## Product Change Notice (PCN)

PCN Number: **PCN-0450884R-01**

Product(s) Affected: **PJ1-023-SMT-TR**

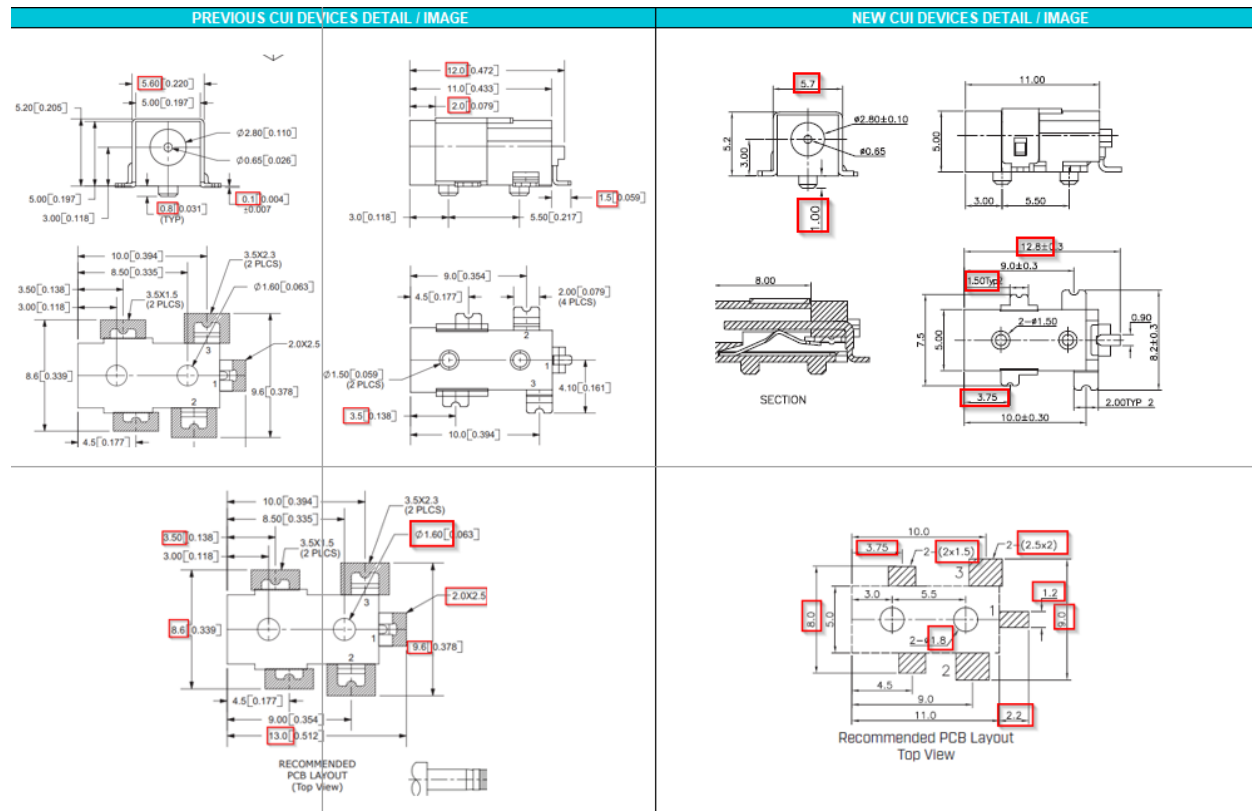
Description of Change: **Minor Housing and footprint differences. Material Change on the housing and terminals. See image Below**

PREVIOUS CUI DEVICES DETAIL / IMAGE			NEW CUI DEVICES DETAIL / IMAGE		
	MATERIAL	PLATING	DESCRIPTION	MATERIAL	PLATING/COLOR
center pin	brass	silver	center pin	brass	silver
terminal 1	brass	silver	terminal 1	brass	silver
terminal 2	copper alloy	silver	terminal 2	SUS301 t=0.25	silver
terminal 3	brass	silver	terminal 3	brass t=0.40	silver
shield	cold rolled steel	nickel	shield	brass t=0.40	silver
plastic	PA6T or equivalent		housing	PA9T (UL94V-0)	black
